11 March 2026

RWDI REFERENCE #: 2512278

**Waterloo Metro Quarter
Pedestrian Wind – Response to DPHI RFI
RWDI Project #2512278**

Figure 20 - Wind comfort and safety targets (ground level)

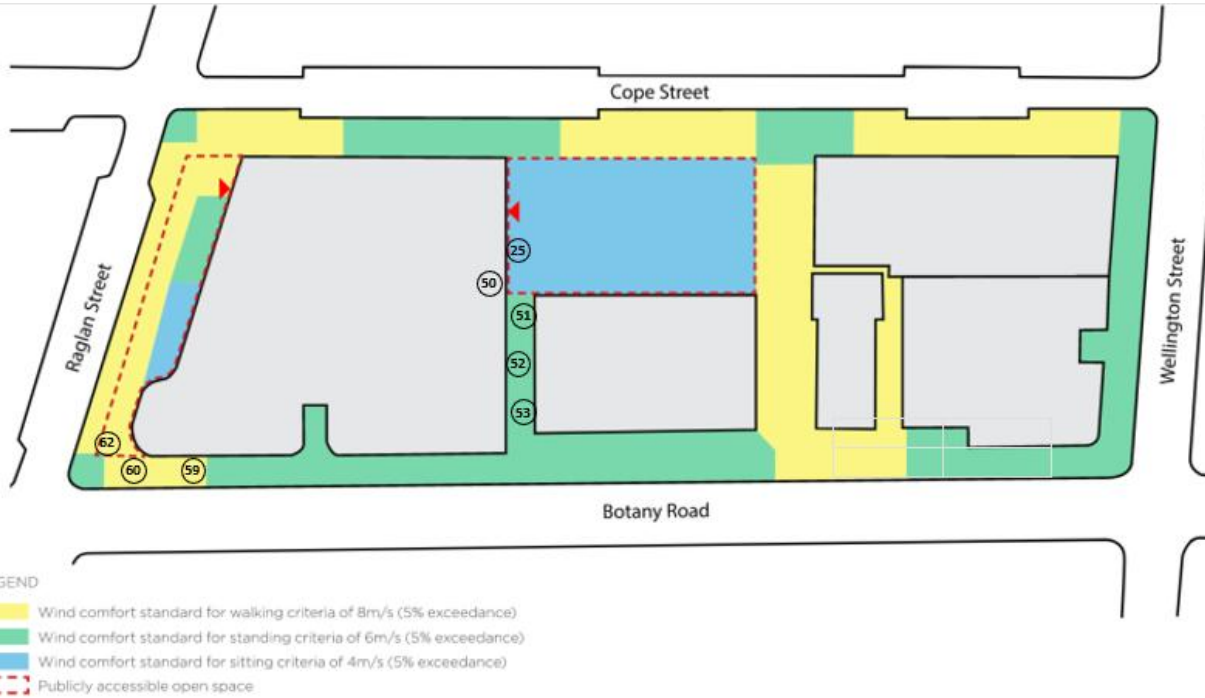
- Provide design solutions and/or mitigation measures that achieve wind comfort outcomes suitable for the intended uses without solely relying on awnings or planting, and consider the following areas:*
 - a sitting criteria for the proposed licensed seating areas on the western ground floor elevation of the Central Precinct (Sensor locations 51, and 53),*

- including incorporation of wind screens and balustrades as stated in section 3.5.1 of the Wind Impact Assessment (Appendix I)*
- b. a standing criteria for Grit Lane between Botany Road and the southern station entrance (Sensor locations 25, 50 and 52)*
 - c. a standing criteria for the corner of Botany Road and Raglan Street (Sensor locations 59, 60 and 62)*
 - d. a sitting criteria for podium and rooftop spaces where outdoor seating / dining and kitchen / study areas are proposed (Sensor locations 124, 125, 128, 129, 130 and 131).*
- b) Demonstrate the proposal would meet the requirements of Condition B14 of the Concept Approval requiring wind comfort, standing criteria to waiting zones at crossings of intersections (e.g. Sensor locations 4, 38 and 61 in the Wind Impact Assessment), including on the opposite sides of the streets.*

For areas where residual exceedances were identified, targeted wind mitigation measures were recommended to supplement the built form strategies and included screening within Church Square and Grit Lane as well as planting throughout the site. The current design of the Proposed Development with the inclusion of these proposed measures is expected to satisfy the criteria requirements of the Design and Amenity Guidelines for most of the zones within the proposed site. The below image and table show the percent of time suitable for the required criteria at the sensor locations relevant to RFI Item 6a (a-c) for the Built Form Only and also with Included Landscaping.

Note the achievement of these required wind conditions are not solely reliant on these additional measures but primarily as a result of the built form massing design including tower setbacks, generous laneways, corner articulation, increased tower separation and other design features borne from the in-depth design process. An example of these features are the awnings that exist throughout the design which fulfill other amenity requirements in addition to addressing wind impacts. In principle mitigation measures were provided for the outstanding areas within Grit Lane to bring the conditions to within standing as required by Design and Amenity Guidelines. These included screening and balustrades within the area as shown in Image 9 of the report, Appendix I - Wind Impact Assessment as submitted as part of SSD-79307746 and SSD-79307758.

Sensor Location	Design Amenities Guideline Criteria	% of Time Suitable (Target 95%)		Compliance / Comment
		Built Form	Include Landscape	
51	Standing	83	86	Proposed screening expected to meet criteria.
53	Standing	88	92	
25	Sitting	79	81	This sensor meets walking criteria, but over 50% of the open space meets sitting criteria as per the guideline.
50	Internal of Building	83	86	The former internal, covered area is now an open-to-sky laneway designed to walking criteria.
52	Standing	88	92	Minor shortfall at 92%, though areas immediately west meet standing criteria
59	Walking	98	99	Achieved & Exceed Criteria
60	Walking	92	98	Achieved & Exceed Criteria
62	Walking	98	100	Achieved & Exceed Criteria

Comfort Levels of Elevated areas and % of Time suitable for target criteria

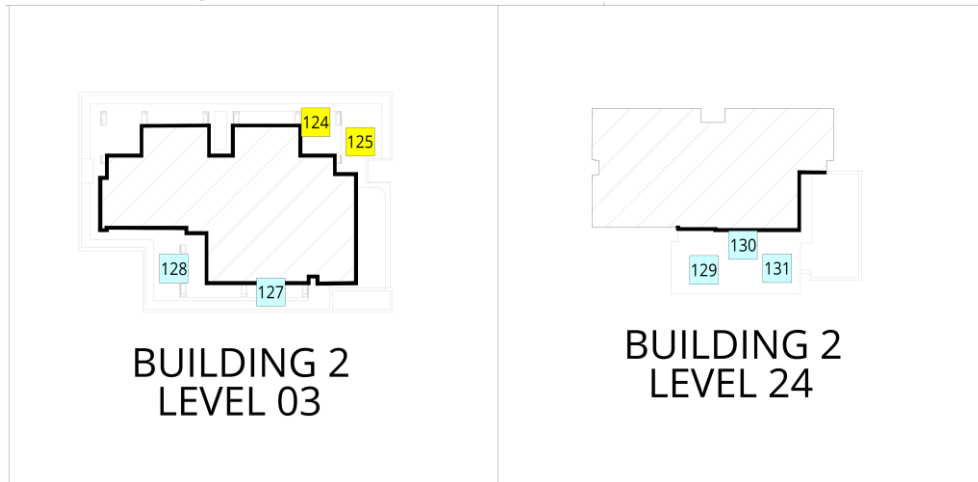
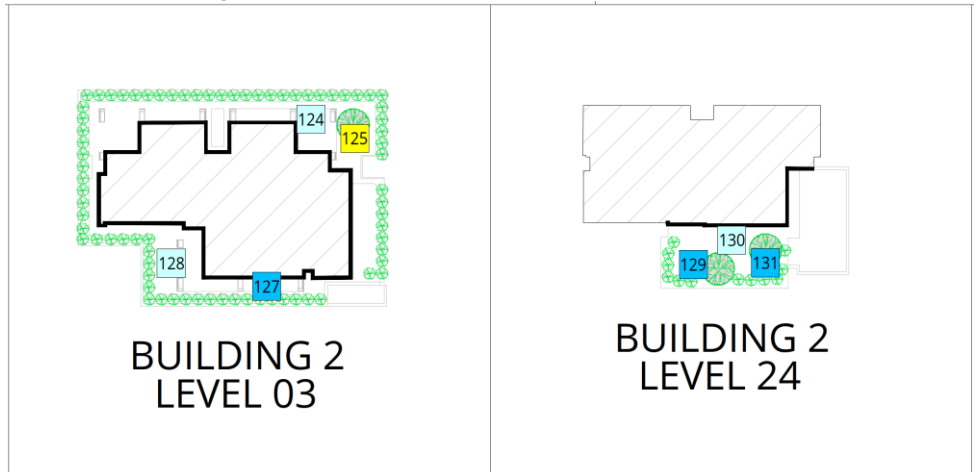
Elevated terrace and rooftops are not governed by the public-domain criteria zones of the Design and Amenity Guidelines. Nonetheless, RWDI assessed these areas using appropriate comfort targets based on intended uses. These targets are achieved through the inclusion of awnings, balustrades, and landscape elements that form part of the inherent amenity and design intent of these terraces, rather than being added solely for wind mitigation purposes. a

The diagrams and table below summarise application of use-specific Design Comfort Targets to each sensor location across the Level 03 terrace and Level 24 rooftop. The selected targets — Walking, Standing, or Sitting, reflect the intended function of each space, including movement zones, low-impact sport areas, BBQ/gathering areas, and outdoor seating/study spaces.

The results show that once the as-designed landscape, awnings, and balustrades are included, all locations achieve or exceed the 95% suitability target for their intended use. Areas not designed for seating (e.g., tree zones or low-impact sport areas) were appropriately assessed using Walking or Standing criteria, and these also meet target conditions.

Sensor Location	Design Amenities Guideline Criteria	Design Comfort Target Appropriate to the Use of the Space	% of Time Suitable (Target 95%)		Compliance / Comment
			Built Form	Include Landscape	
124	n/a	Standing	88	97	Intended use is low-impact sport zone; no seating, meets criteria.
125	n/a	Walking	96	99	Area allocated for a large tree beside low-impact sport use; not intended for seating, meets criteria.
128	n/a	Standing	98	98	Achieved & Exceed Criteria
129	n/a	Sitting	89	98	Achieved & Exceed Criteria
130	n/a	Standing	98	99	Area in front of the core wall is the BBQ zone, a gathering area that meets & exceed standing criteria
131	n/a	Sitting	91	97	Achieved & Exceed Criteria
